Access Compliance Report

Public Rights-of-Way

(Curb Ramps)

Intersection ID: 45167	Main Street: ARAGORN_LN	Cross Street: STRIDER_DR	Location:	N
ADA ID: B57413FEB8ED	Ramp Type: BlendTrans1	Initial Pass/Fail: Fail	Overall Compliance: No	Severity Score: 17.5
Codes/Mitigation Info/Possible Solution		Field Measurements/Component Compliance

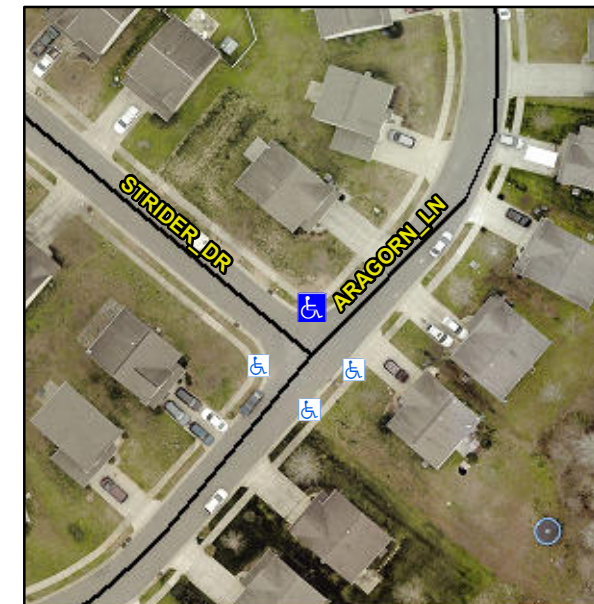
Not Found, R304.5.1

Compliance	Description	Data	Compliance	Description	Data
N/A	Ramp Length (in)	48.0	Yes	BlendTrans Slope (%)	4.3
No	Ramp Width (in)	33.0	Yes	BlendTrans XSlope (%)	1.4
N/A	Flare Type LT	N/A	N/A	Flare Type RT	N/A
N/A	Flare Slope LT (%)	N/A	N/A	Flare Slope RT (%)	N/A
N/A	Flare Traversable LT?	N/A	N/A	Flare Traversable RT?	N/A
N/A	Landing Length (in)	N/A	N/A	DWS Provided?	N/A
N/A	Landing Width (in)	N/A	N/A	DWS Contrast?	N/A
N/A	Landing Slope (%)	N/A	N/A	DWS Length (in)	N/A
N/A	Landing X Slope (%)	N/A	N/A	DWS Full Width?	N/A
N/A	Landing Curb? (Y/N)	N/A	N/A	DWS Offset (in)	N/A
N/A	Shared Landing?	N/A			
N/A	Gutter Ponding?	N/A	N/A	Gutter Slope (%)	N/A
N/A	Gutter Lip Ht (in)	N/A	N/A	Gutter X Slope (%)	N/A
N/A	Painted X Walk1?	No	N/A	Painted X Walk2?	No
	X Walk 1 Direction	To SW		X Walk 2 Direction	To SE
	X Walk 1 Width (in)	N/A		X Walk 2 Width (in)	N/A
	X Walk 1 Slope (%)	3.5		X Walk 2 Slope (%)	1.9
	X Walk 1 X Slope (%)	2.6		X Walk 2 X Slope (%)	1.4

N/A	Ramp inside XWalk1?	N/A	N/A	Ramp inside XWalk2?	N/A
	Road Slope (%)	0.0		Clear Space?	N/A
	Road X Slope (%)	0.5	N/A	Clear Space to XWalk (in)	N/A
N/A	Any Obstructions?	N/A	N/A	Storm Grate/Utility Hazard?	N/A
	Obstruction Type			Storm Grate/Utility Type	
		N/A			N/A
			Yes	Surface Condition? (G/P)	Good
			No	Curb Slope (%)	14.9

Remove & Replace Curb Ramp With Two New Directional Ramps or Equivalent.
